APPLICATION FOR A CERTIFICATE OF APPROPRIATENESS – STAFF REPORT

091-17-CA 518 E LANE STREET
Applicant: MICHELLE AND ALEXANDER LATSKO
Received: 5/10/2017 Meeting Date(s):
Submission date + 90 days: 8/8/2017 1) 6/22/2017 2) 3)

Nature of Project: Replace rear patio and parking pad; add privacy screen and railing; install sod

Pictures of proposed pavers for parking area

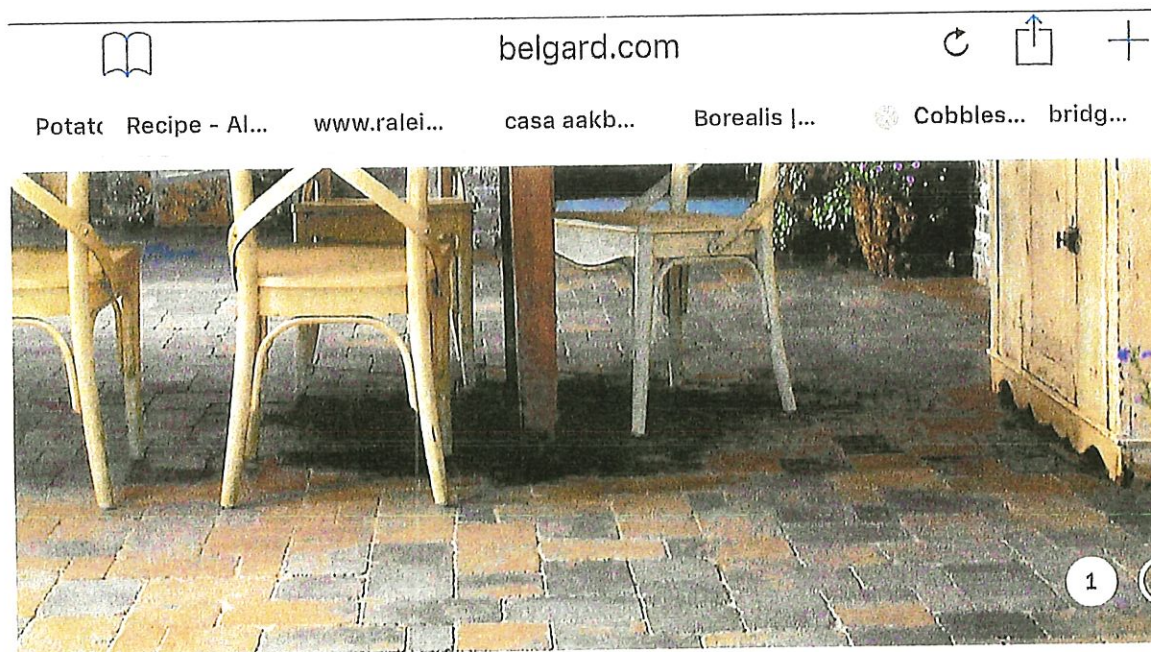
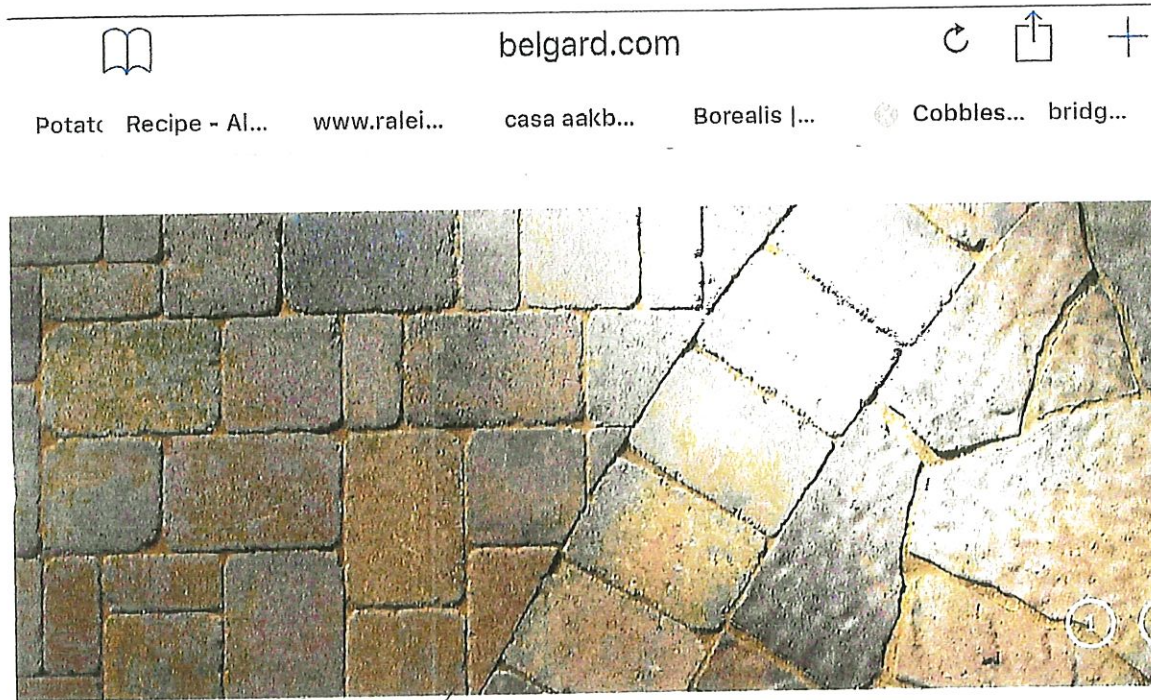
- 6* The proposed driveway parking pad will be the same dimensions as the existing, and is proposed to be multi-colored block pavers with a semi-cobblestone appearance. Block pavers and cobblestones are not a common driveway/parking pad material in the Oakwood district.
- 7* Given that the dimensions of the existing hardscape will not be changing, the percentage of built area to open space is not changing.
- 8* There are no trees in the rear yard or adjacent yards.

- 1. That alternate materials are selected for the patio and parking pad.
- 2. That the railing not be installed.
- 3. That a low wood fence be approved in the location of the proposed railing.
- 4. That details and specifications for the following be provided to and approved by staff prior to the issuance of the blue placard:
 - a. Height of the privacy screen.
 - b. Fence design.
 - c. Precise dimensions of fence and opening.
 - d. Patio material.
 - e. Parking pad material.

Picture of proposed paver
for patio area

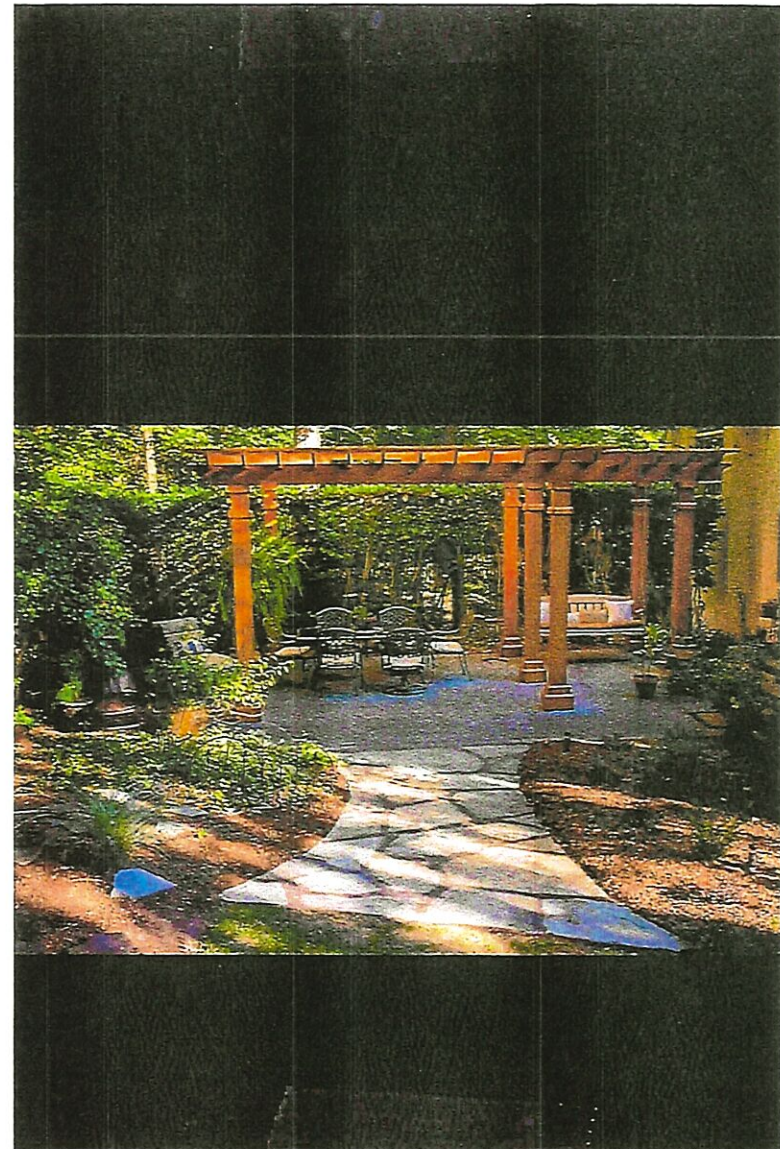
- 3* The proposed new patio will be the same dimensions as the existing, and is proposed to be of a 5"x10" concrete unit product with a faux wood finish.

- 4* The committee has not yet approved the use of a material with a faux wood appearance. Evidence was not provided to support its adherence to the Guidelines.

Photo of Screen and
Trellis Design

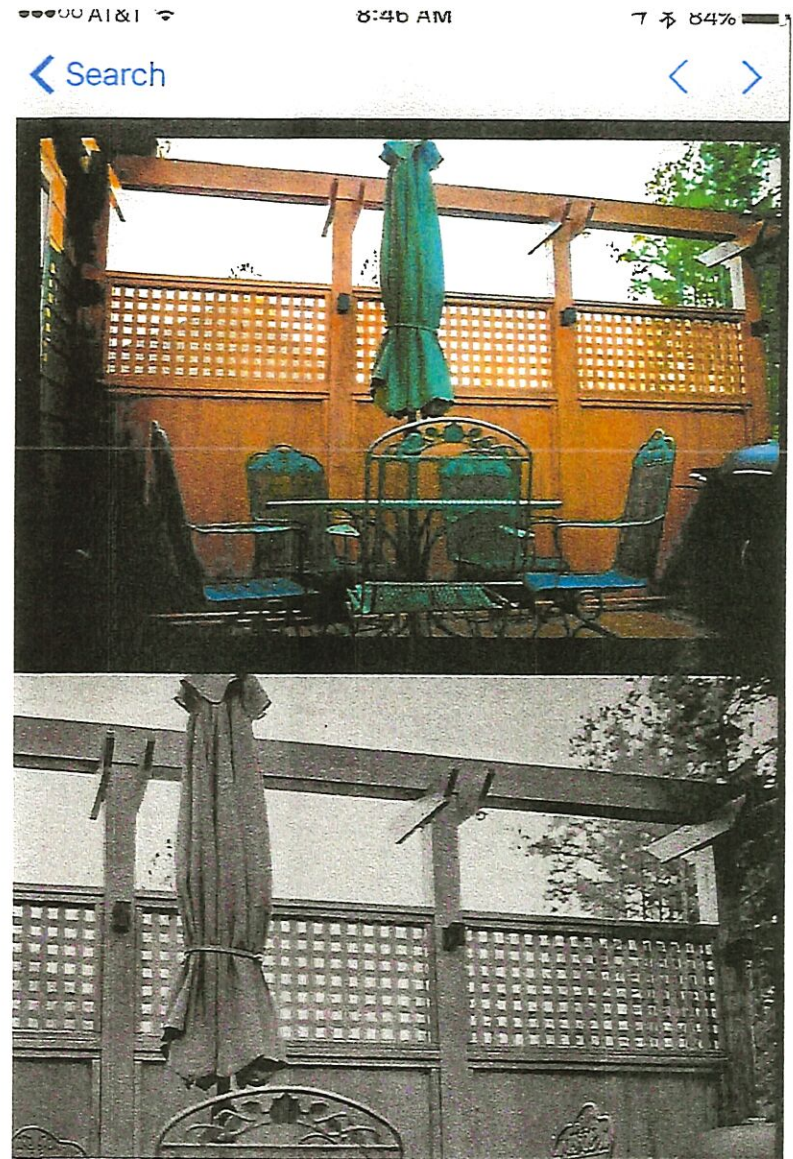
- 2* The applicant describes the privacy screen as 9' tall x 12' wide on the application, although the drawing shows it at roughly 10 ½' tall. It will be constructed of wood.

- 3* Lattice screens are sometimes seen on the sides of open porches. The proposed screen is similar in purpose.
 - 4* The screen is solid for the lower 6', with a 2' tall lattice above and an open space between the lattice and the top beam. With the solid character of the lower portion of the screen it behaves more like a 6' privacy fence than an open screen.

- 5* Privacy fences 6' tall are regularly approved along rear yard side property lines.
 - 6* The privacy screen appears to be anchored to the rear wall of the house.
